SAN BERNARDINO INTERNATIONAL AIRPORT AUTHORITY

REGULAR MEETING AGENDA

WEDNESDAY, FEBRUARY 22, 2023

5. Approve Change Order No. 1 in the amount of $18,550.00 with AEC Moreno Corporation for a total contract amount not to exceed $68,050.00 for the 1st Floor Concession Stand Improvements Project

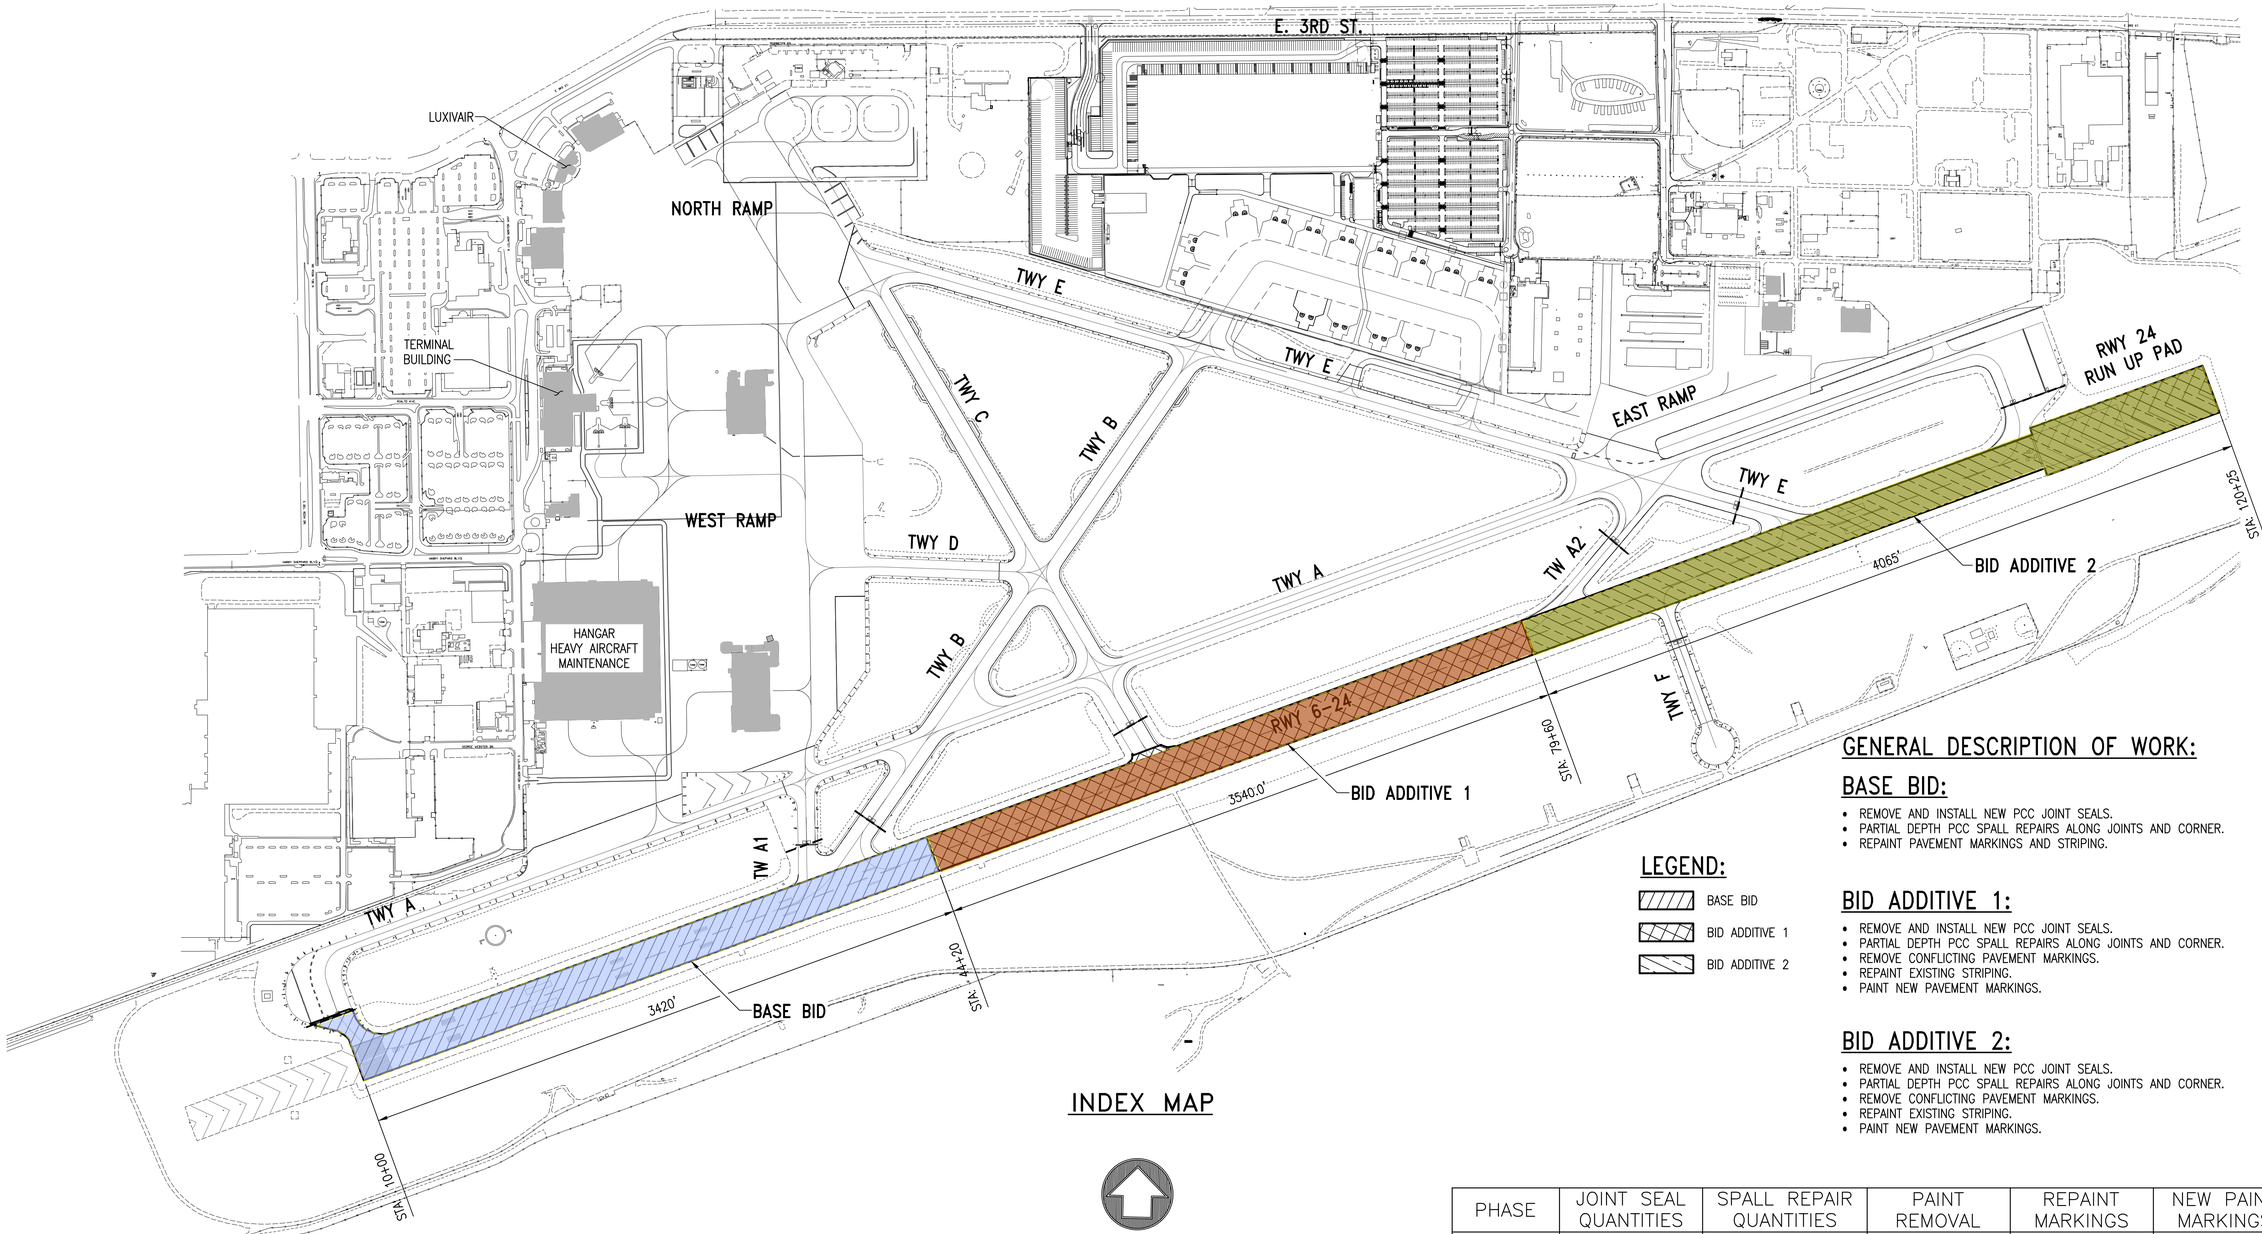
On May 25, 2022, the San Bernardino International Airport Authority (SBIAA) Commission authorized the award of a contract with Goss Construction Co. Inc. for the Runway 6/24 Joint and Spall Repair Project. This project provides for the re-construction of expansion joints between each of the concrete panels throughout the runway. The project includes repair of minor concrete spalls prior to reconstructing the expansion joints, and re-painting the runway upon successful completion of the joint and spall repair work.

During the course of construction, staff determined that runway access limitations on work hours, weather delay related impacts, traffic control, and low temperature paint was needed to properly complete the necessary scope of work, in consideration of runway availability and utility for airfield tenants.

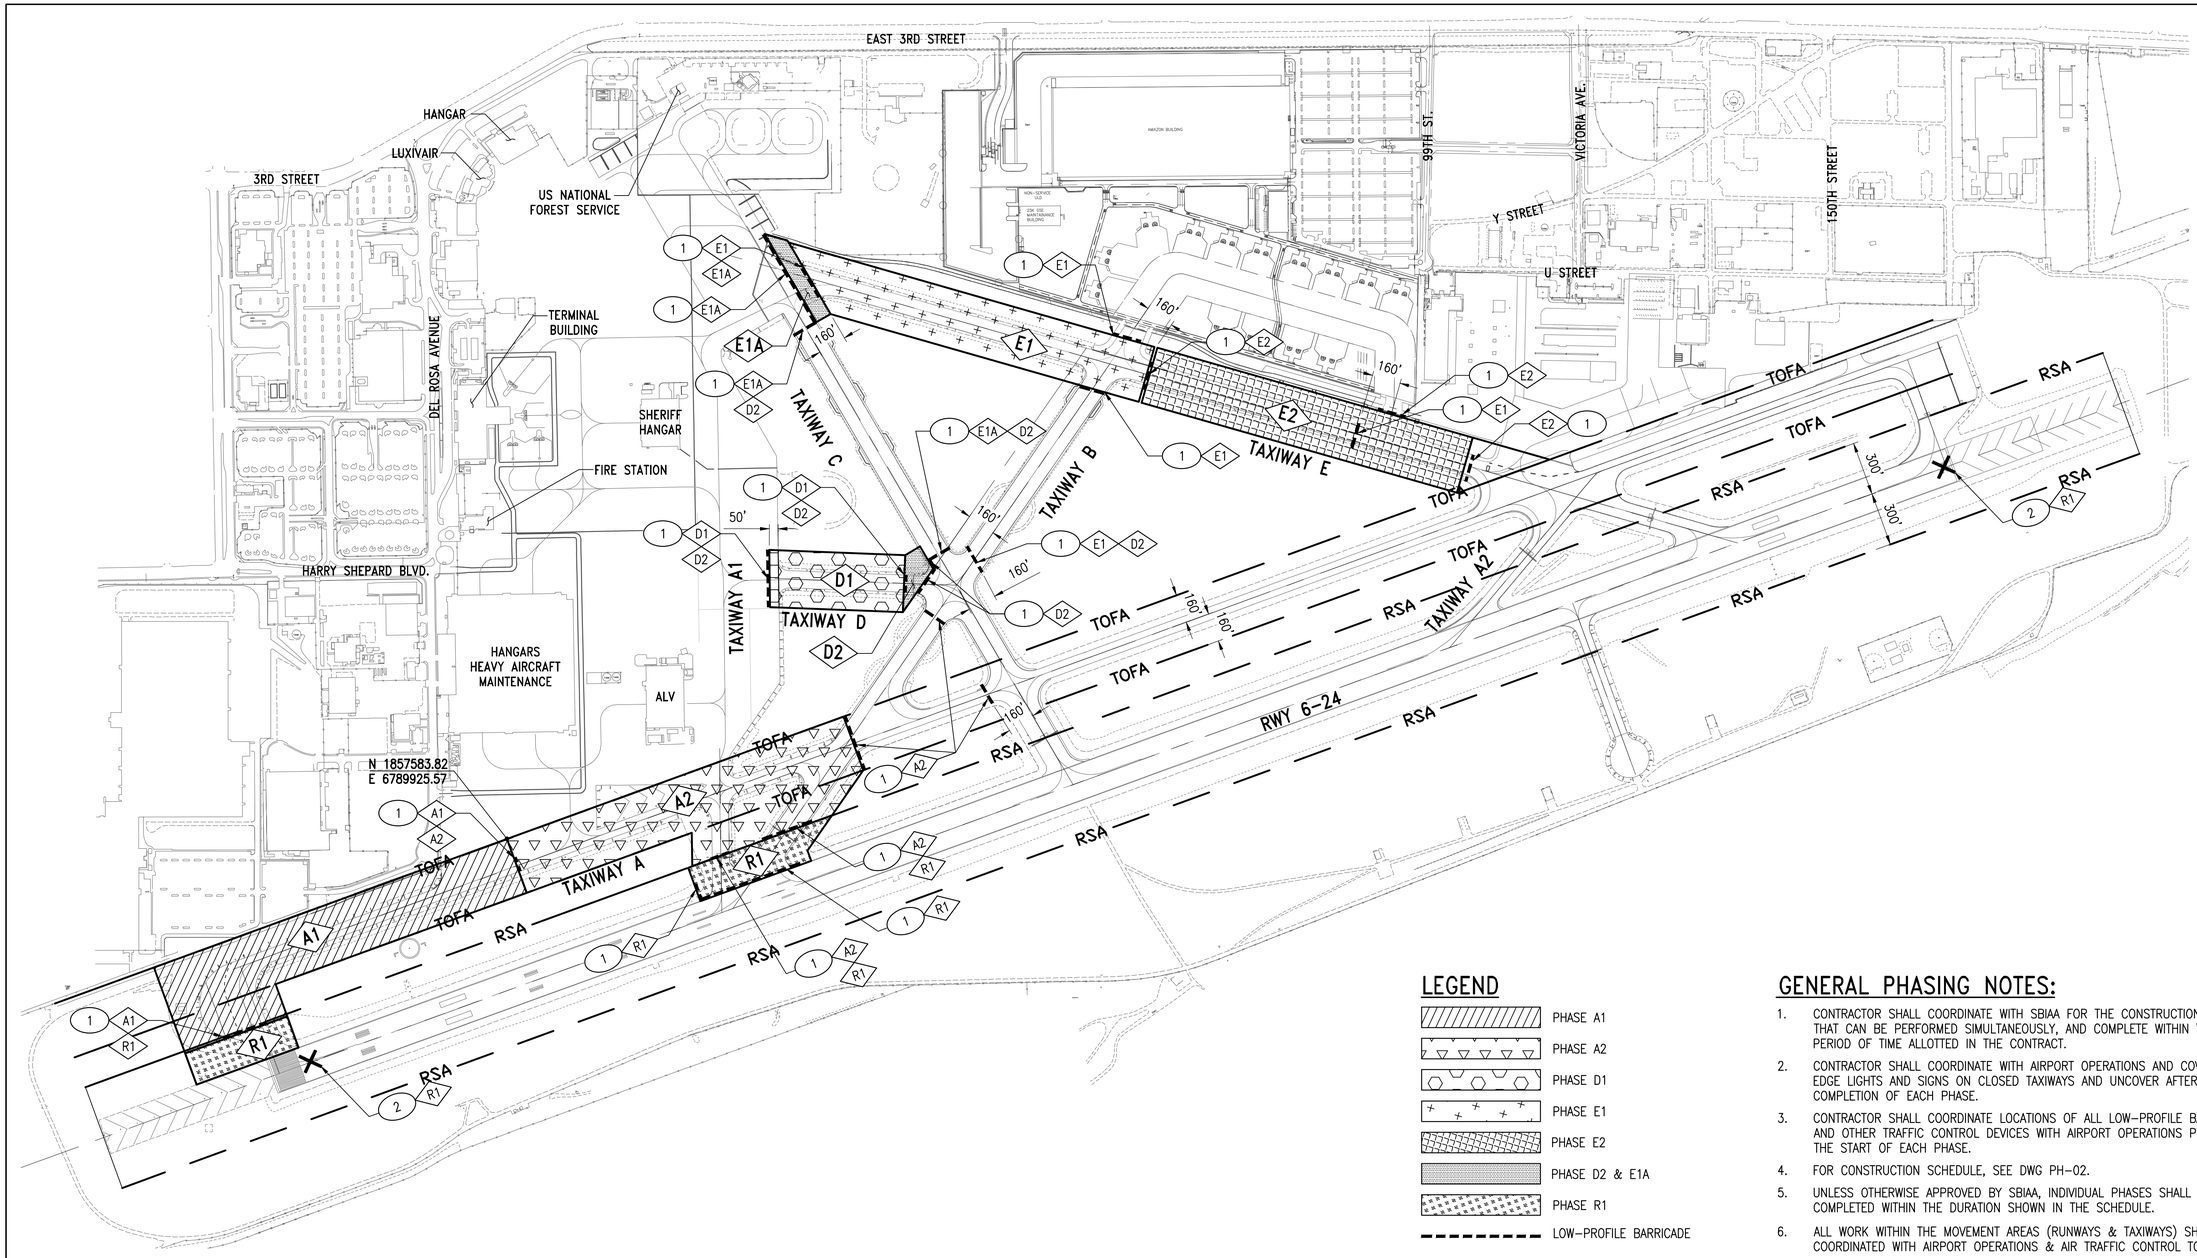
On November 24, 2021, the San Bernardino International Airport Authority (SBIAA) Commission authorized Staff to advertise construction plans for this project. Project plans and specifications were advertised as a Notice Inviting Bids on the SBIAA website and notices published in four (4) local newspapers in accordance with SBIAA Policies and Procedures, and Federal Aviation Administration (FAA) Procurement Requirements. Two (2) qualified contractors submitted sealed bids on January 11, 2022, of which Griffith Company submitted the most competitive bid proposal for this project.

During the course of construction, Staff determined the native material in a portion of the Taxiway A1 shoulder area, and fillet section at the west end of Taxiway A required additional sub-base material.
